job title			
CAMDEN LOCK VILLAGE			
drawing title / location			
PROPOSED ELEVATIONS W+X NORTH AND SOUTH			
drawn by	checked	scale	status
		1 : 250 @ A1	PLANNING
project	drawing no.	revision	
12001	B_(00)_200	D

job title			
CAMDEN LOCK VILLAGE			
drawing title / location			
PROPOSED ELEVATIONS W+X EAST AND WEST			
drawn by	checked	scale	status
		1 : 250 @ A1	PLANNING
project	drawing no.	revision	
12001	B_(00)_201		D

drawing title / location  
BUILDING W+X  
PROPOSED BAY STUDIES

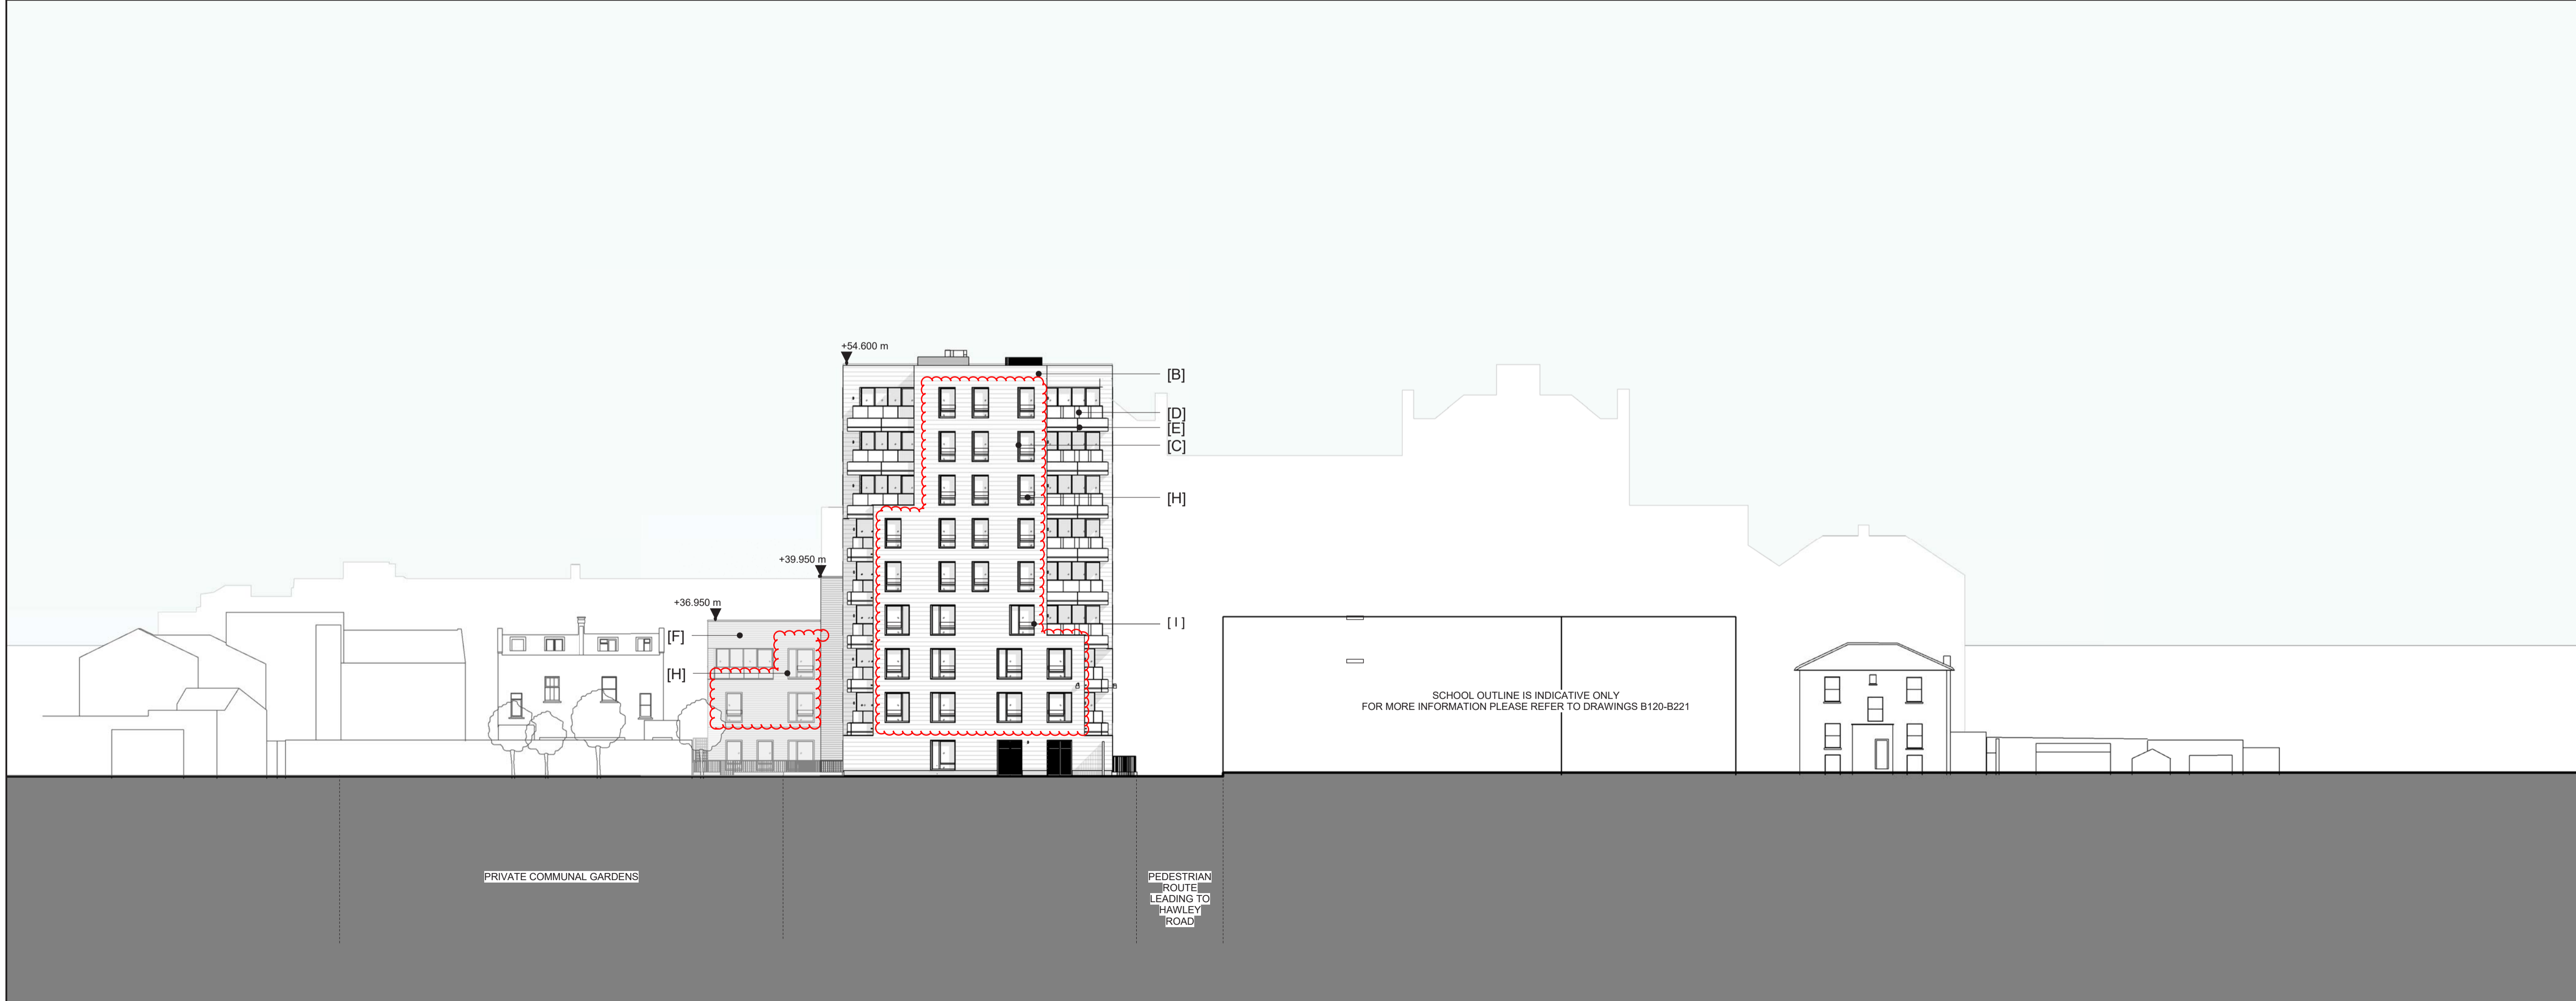
Rev C 08.04.19 Balustrading added to 1/F - 4/F Windows  
 rev B 09/02/18 Regularisation Planning Submission  
 REV DATE DESCRIPTION

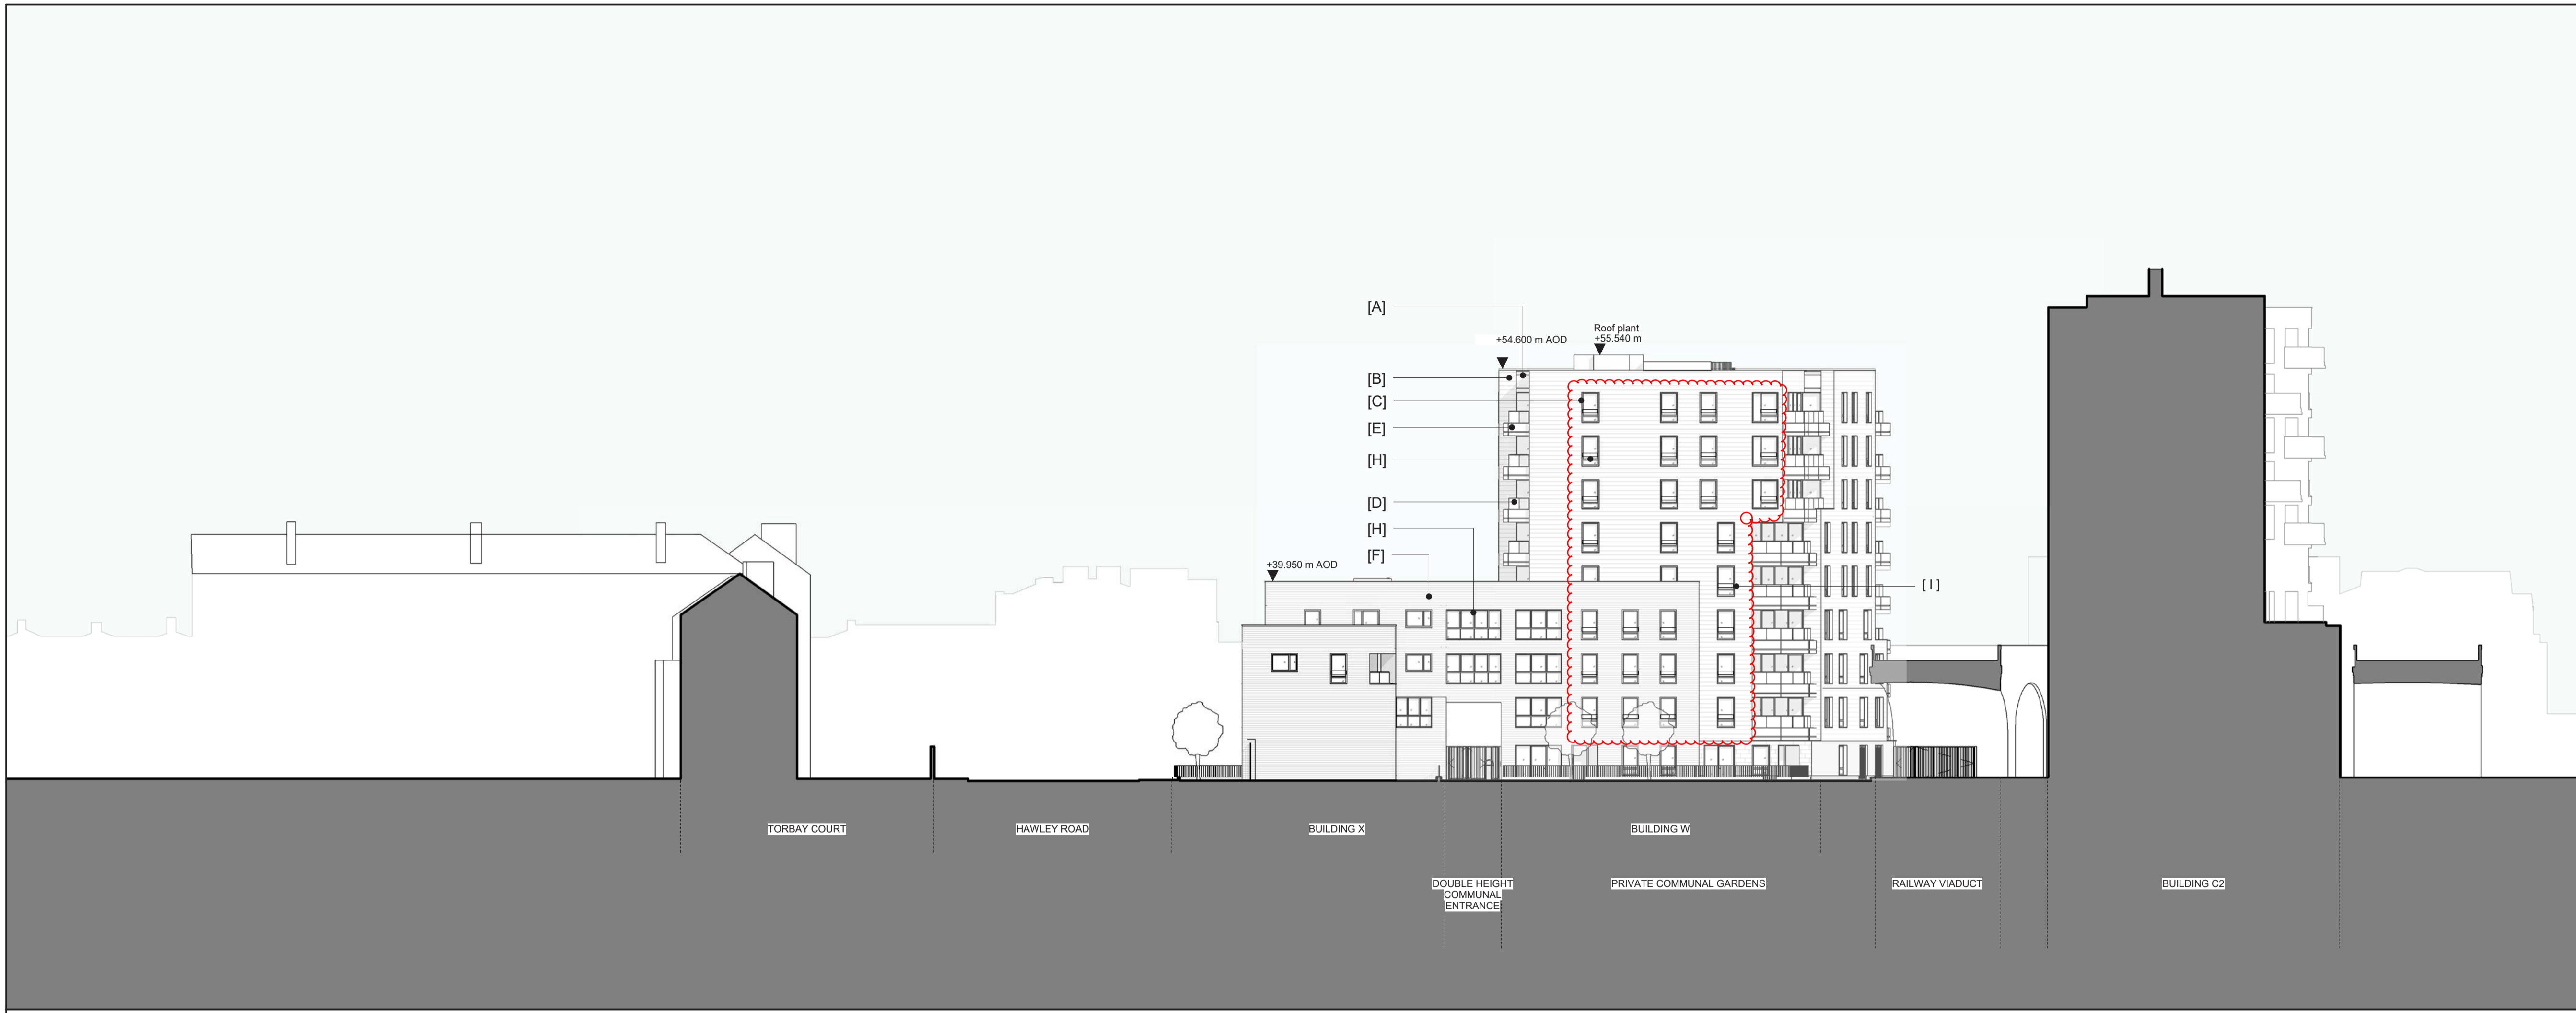
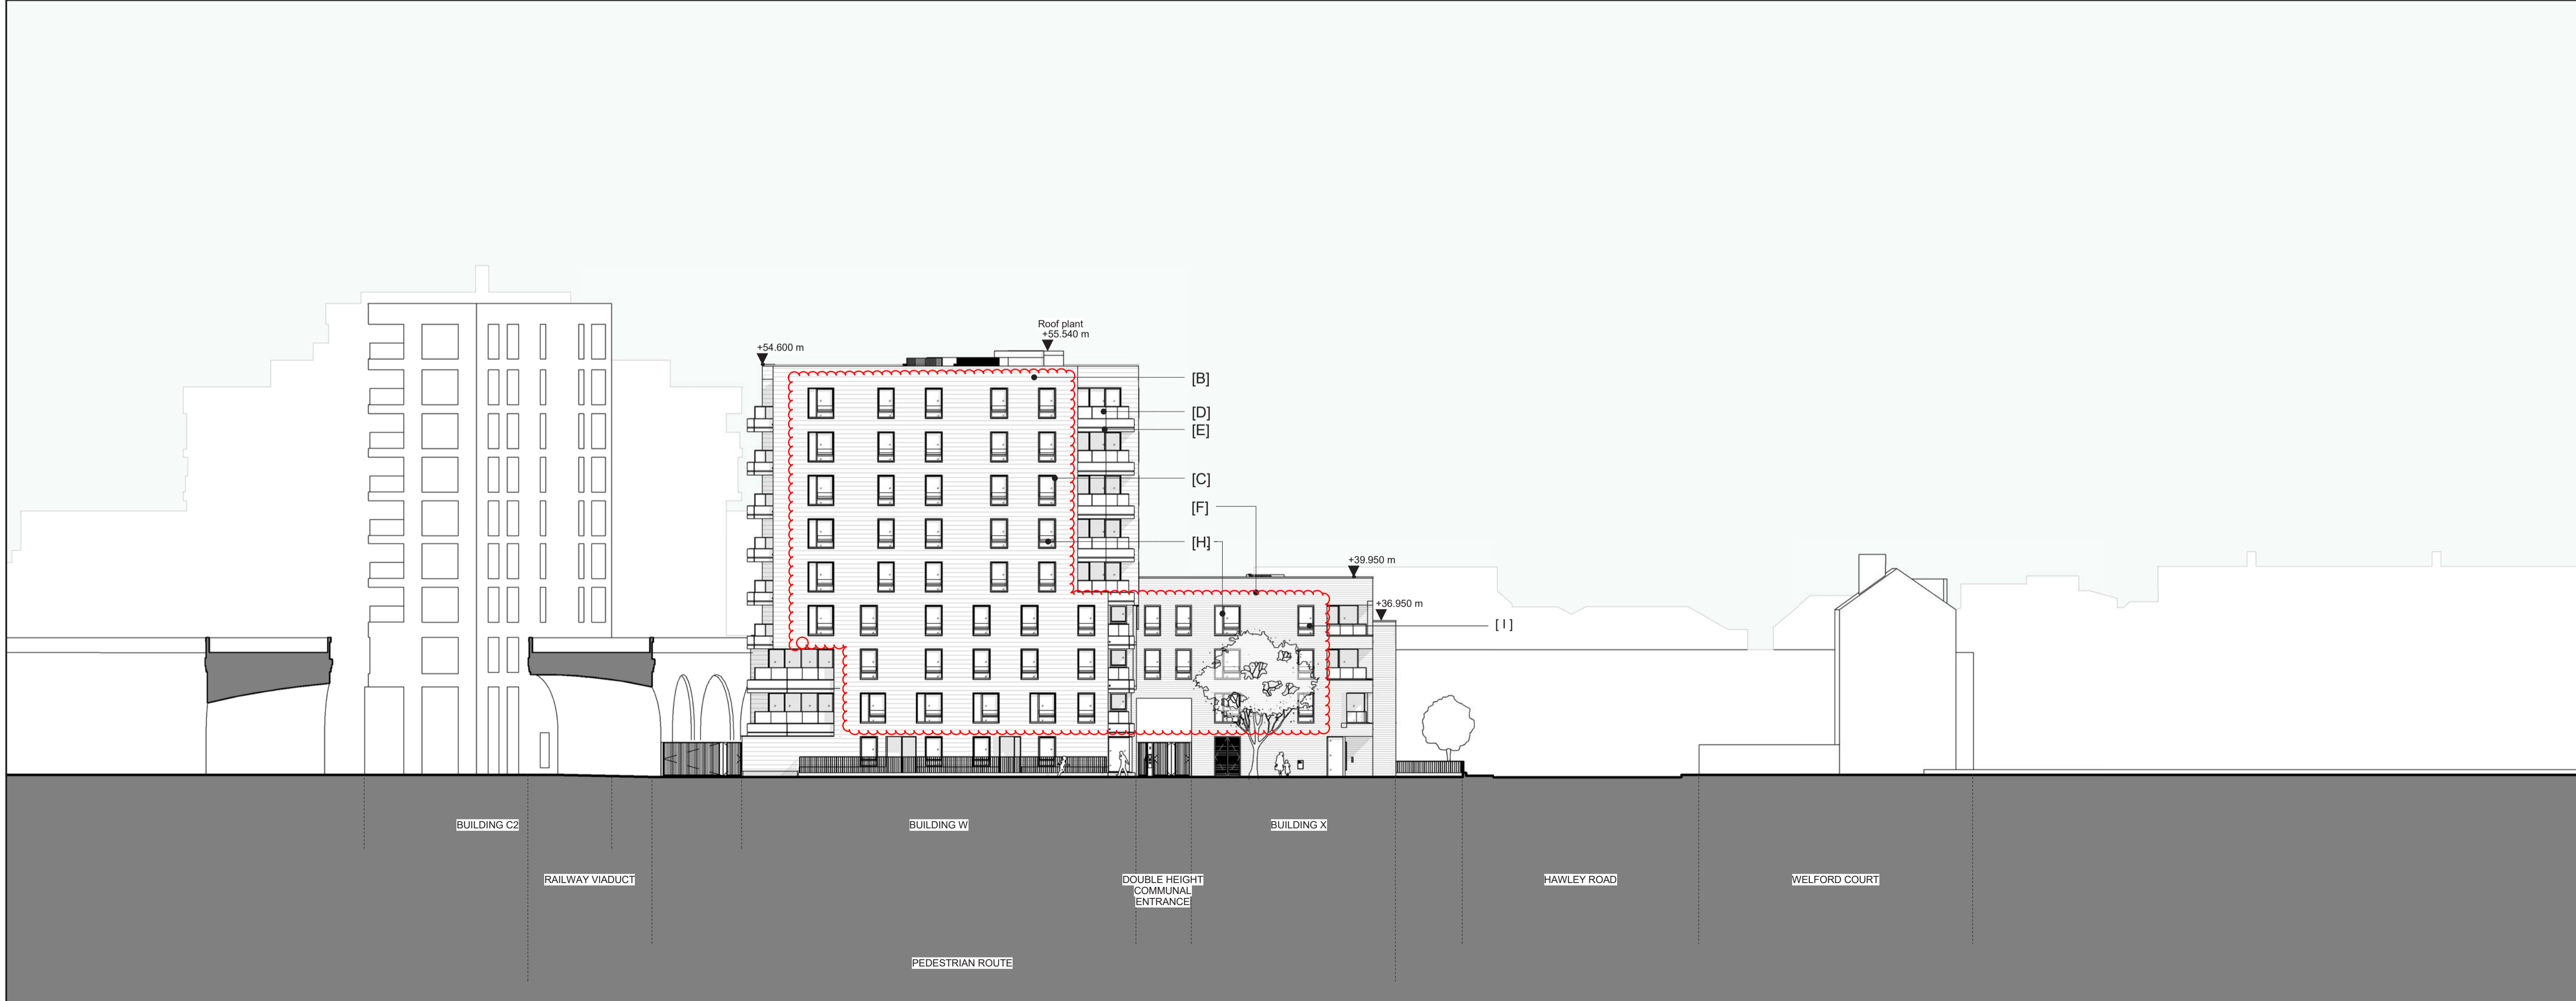
Rev C 08.04.19 Balustrading added to 1/F - 4/F Windows  
 rev B 09/02/18 Regularisation Planning Submission  
 REV DATE DESCRIPTION

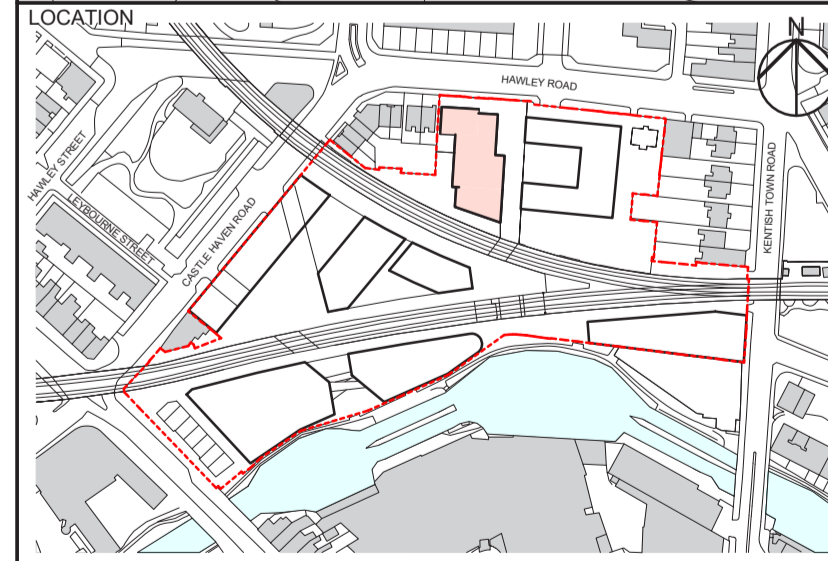
Rev C 08.04.19 Balustrading added to 1F - 4F Windows  
 Rev A xxx/18 Regularisation Planning Submission  
 REV DATE DESCRIPTION
